Request For Information RFI-014

Subject: BP3 Boiler Plant UG Plumb Conf
Project: Steamboat - BV BP Promenade and Goldwalk
Address: 2305 Mount Werner Circle
Steamboat Springs CO 80487 USA
Phone:
To: Zach Ray
MTech Mechanical Technologies Group, Inc.
From: Saunders Construction, LLC Alec Hallman

**GOLD WALK - PLUMBING PLAN -
LEVEL 01**

1B-P1.201

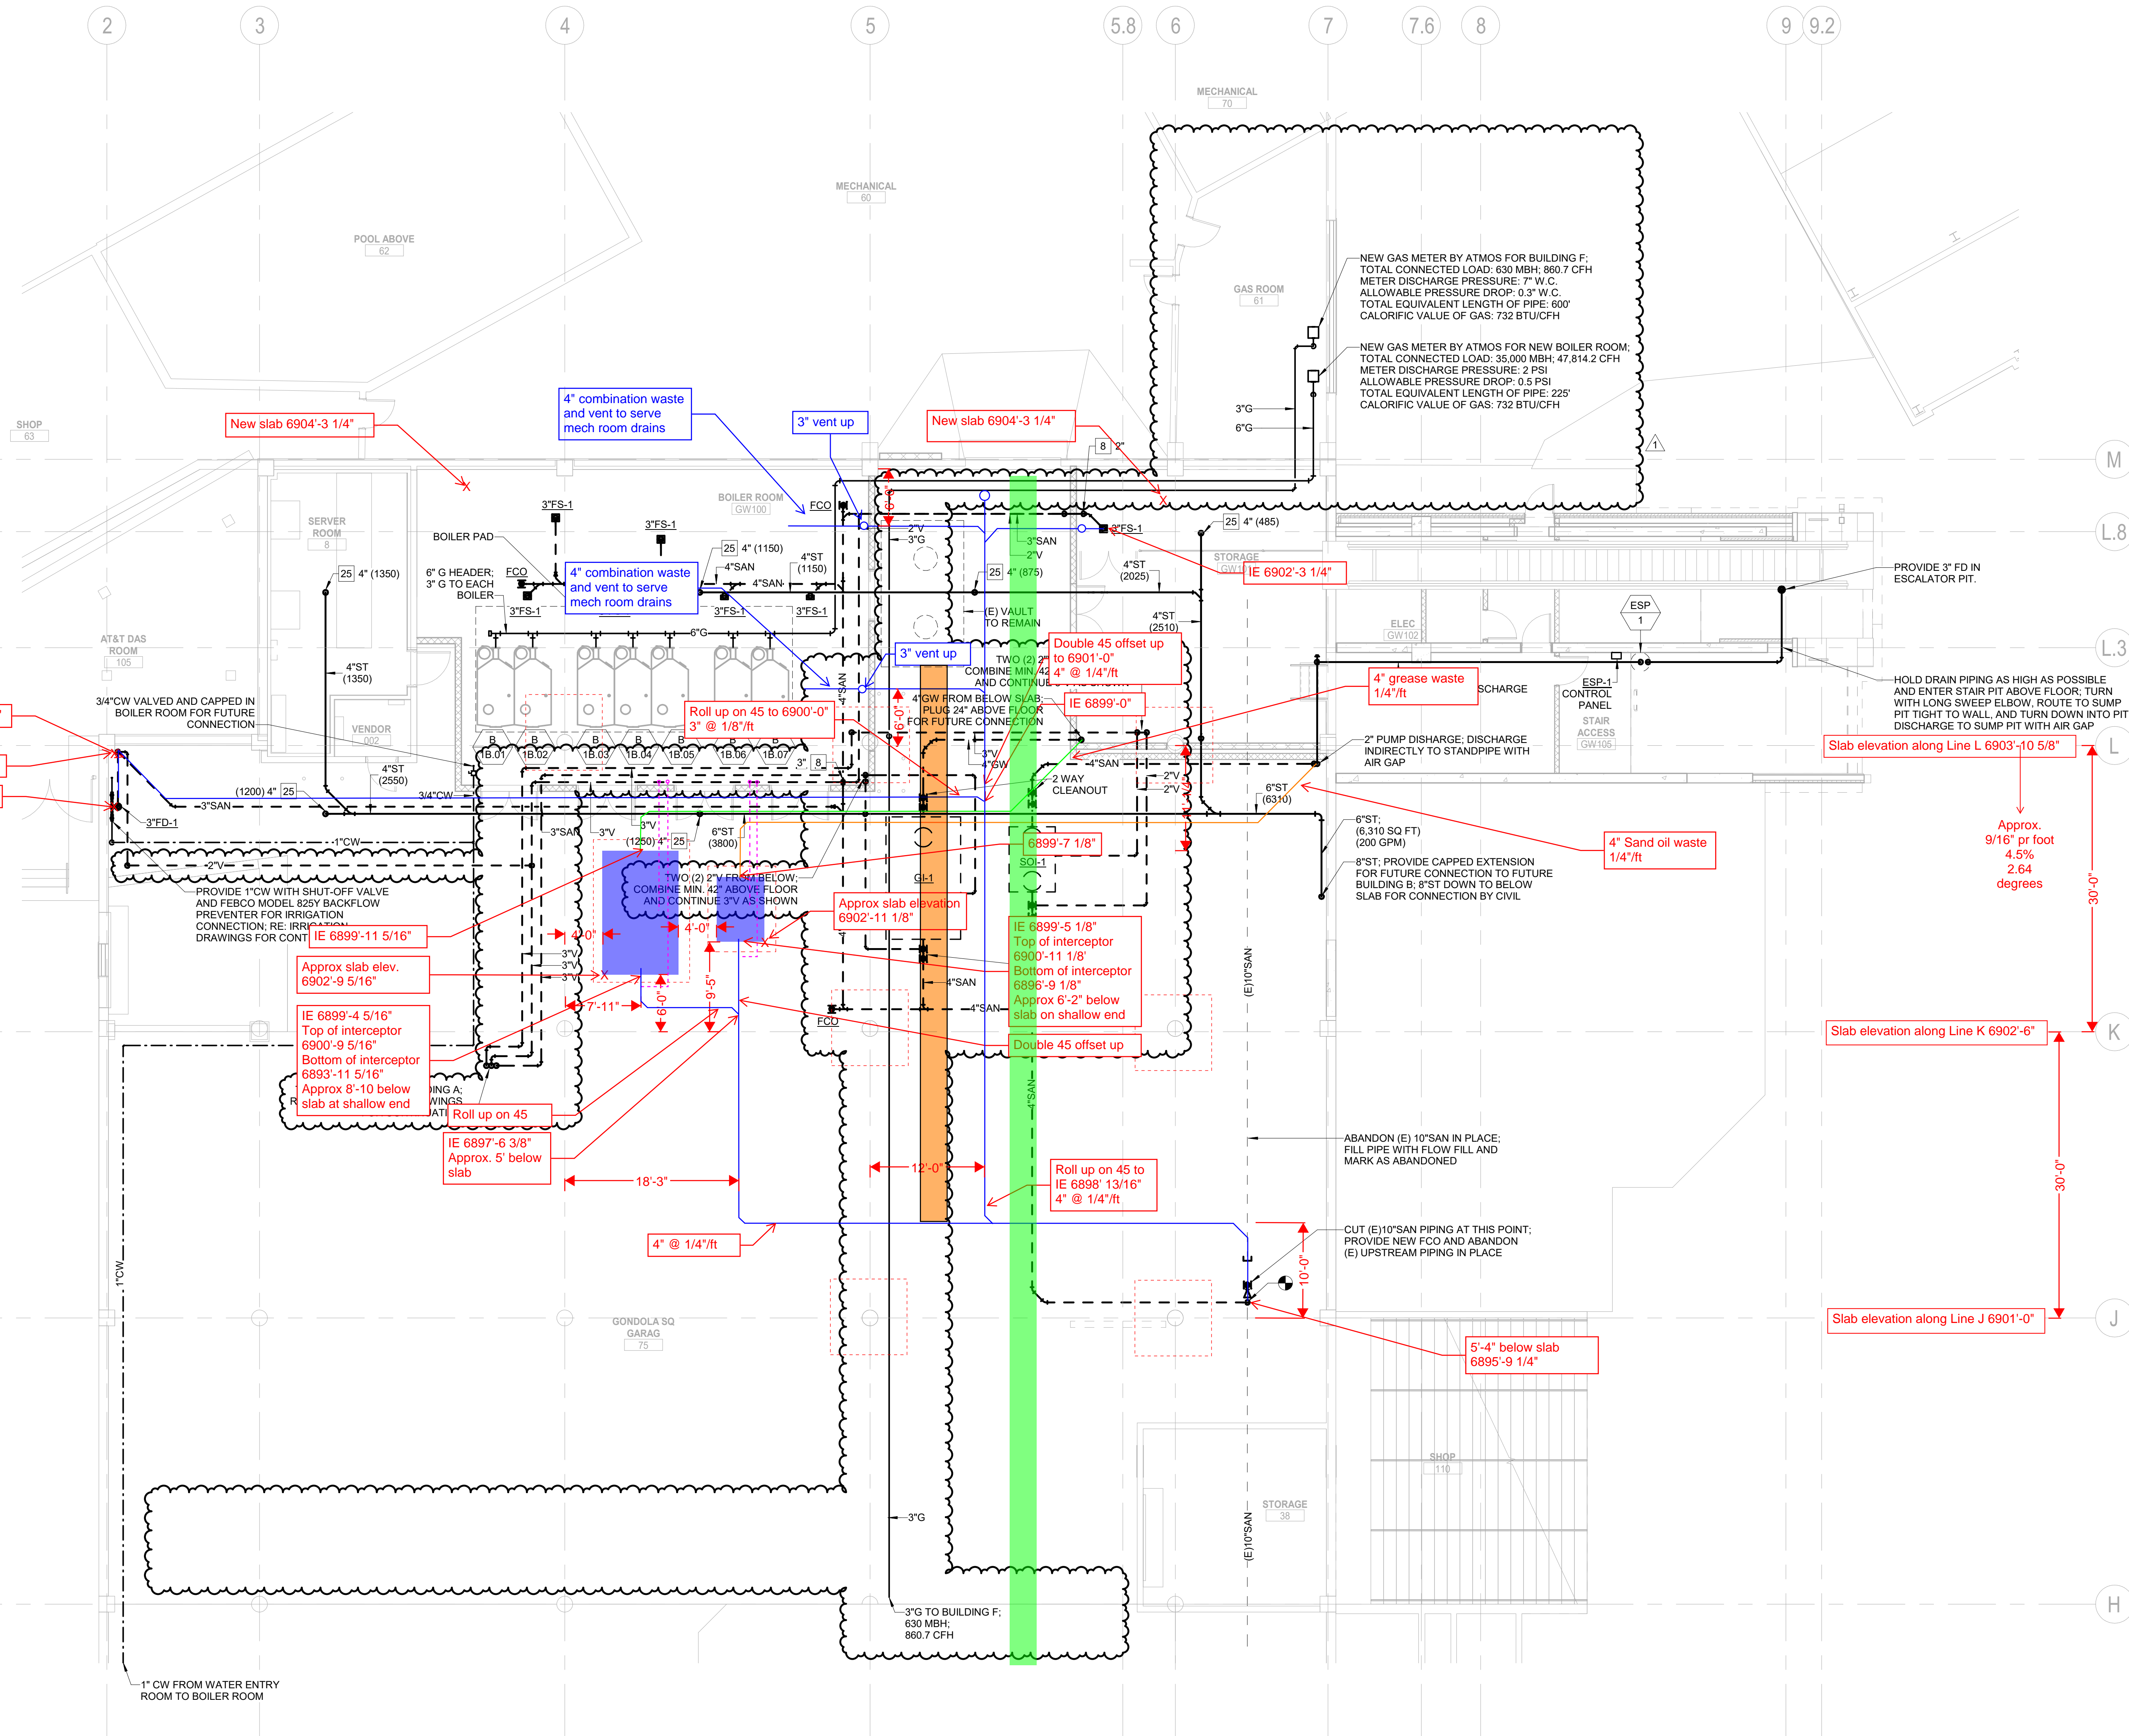
Ref attached correspondence and underground plan 1B-P1.201 please confirm revised layout is acceptable.

Ref attached correspondence and underground plan please confirm revised layout is acceptable.

This copy also indicates the underground storm main (green), that is the reason for also relocating SOI-1.

ME Engineers takes no exception to the revised interceptor locations. The boiler room and snowmelt pump station are undergoing VE exercises which will impact the locations of drains in those areas. Underground piping in the boiler room and snowmelt pump room are subject to change with upcoming VE.

For the interceptors, I would like to have the new location indicated in an RFI so that it's on record. We will then make updates to our plans to match these locations in a future drawing update.
